SOLANO COMMUNITY COLLEGE  KITCHELL MADI ARCHITECTURE + PLANNING	ADDENDUM #01
	Project: #16 – 007A Solano Community College District Horticulture Site Improvements
	Date: June 27, 2016

- ITEM 1: REVISED Sheet A2.5A (Farmers Stand)
DELETE Sheet A2.5A issued with bid and replace with **REVISED** Sheet A2.5A attached with this Addendum

- ITEM 2: REVISED Sheet A2.3A (Greenhouse)
DELETE Sheet A2.3A issued with bid and replace with **REVISED** Sheet A2.3A attached with this Addendum

- ITEM 3: REVISE Sheet FM-01 (Greenhouse)
DELETE Sheet FM-01 issued with bid and replace with **REVISED** Sheet FM-01 attached with this Addendum

REVISIONS			
DATE	12/30/14	SCALE	N.T.S.
JOB NO.		DRAWN BY	AGM
APPROVED			
TITLE	18' X 36' HOBBY HOUSE	JOB NAME	
ENGINEER			
LOADING	12LL-100-C		
DRAWING NO.			
DRAWING SET	FM-01		
SHEET	1 OF 2		
CERTIFICATION

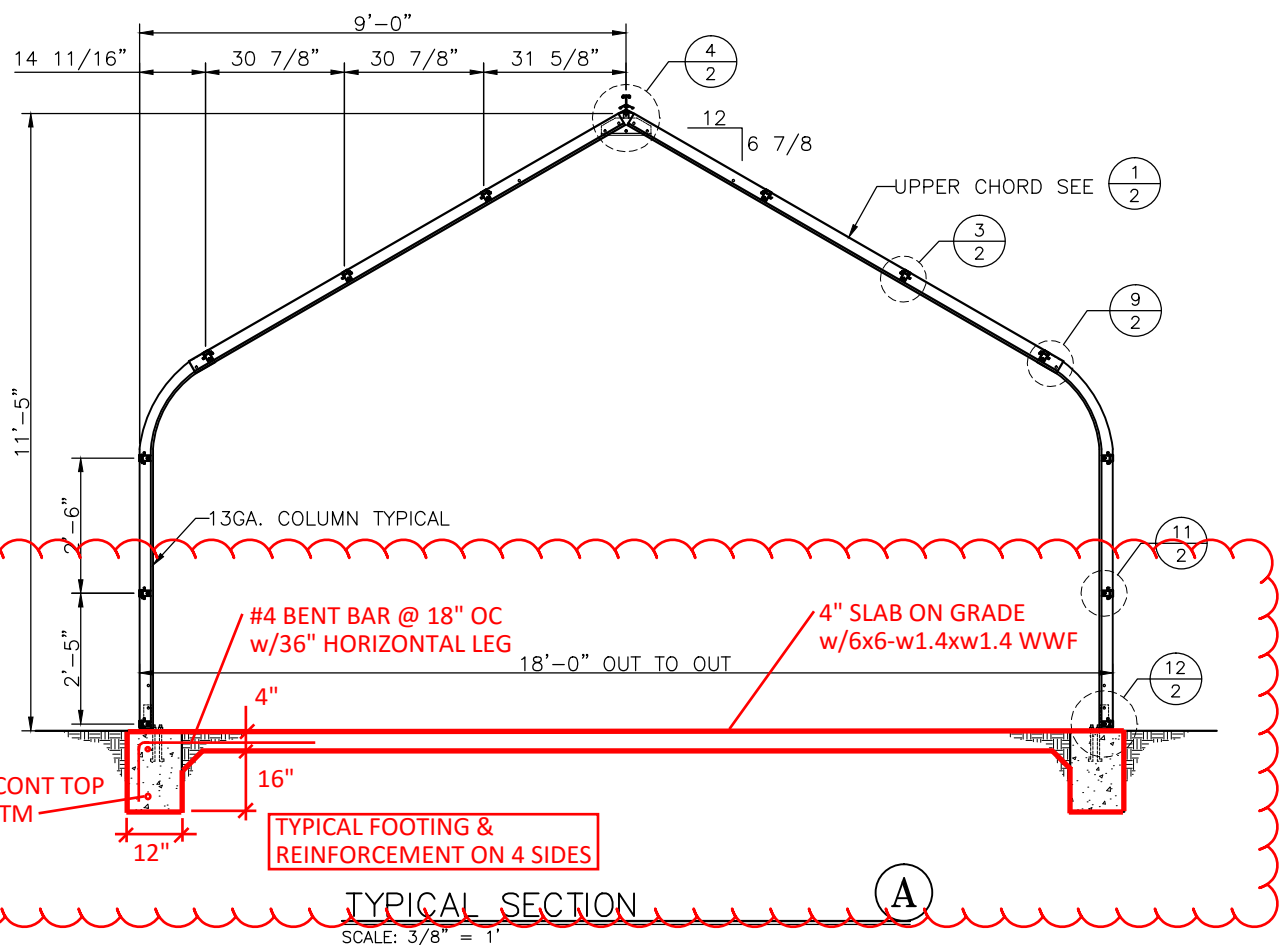
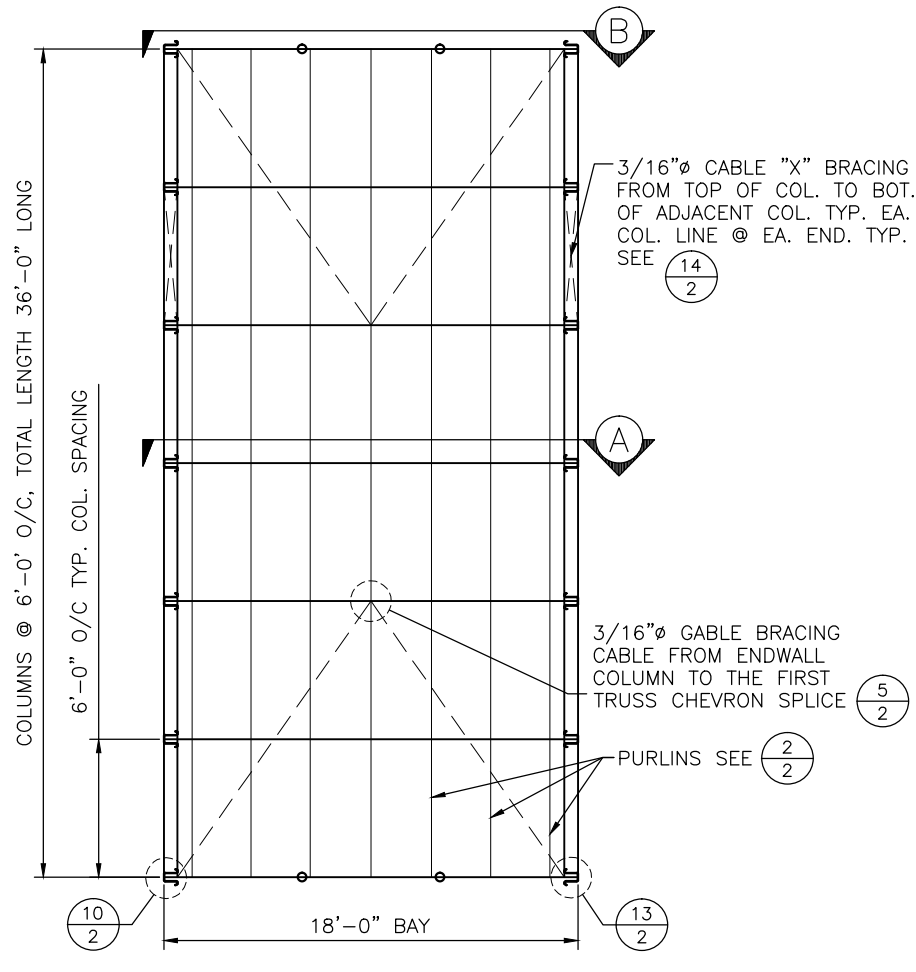
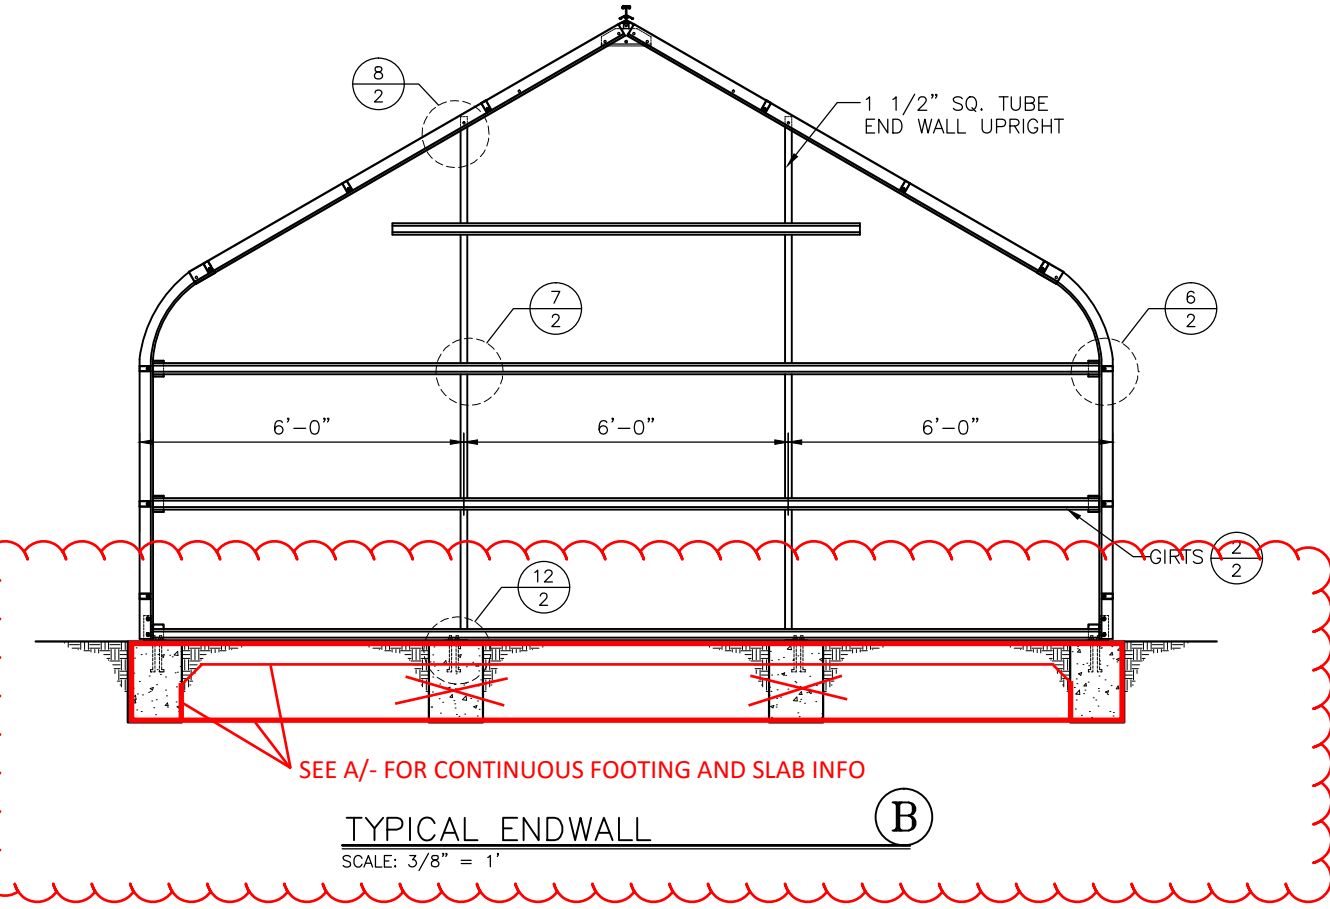
10. Slab footings for greenhouse are not shown however they are identified in note 1 as being required. Please provide width, depth, length and locations of footings.

A: See Section B, ITEM 2 and ITEM 3
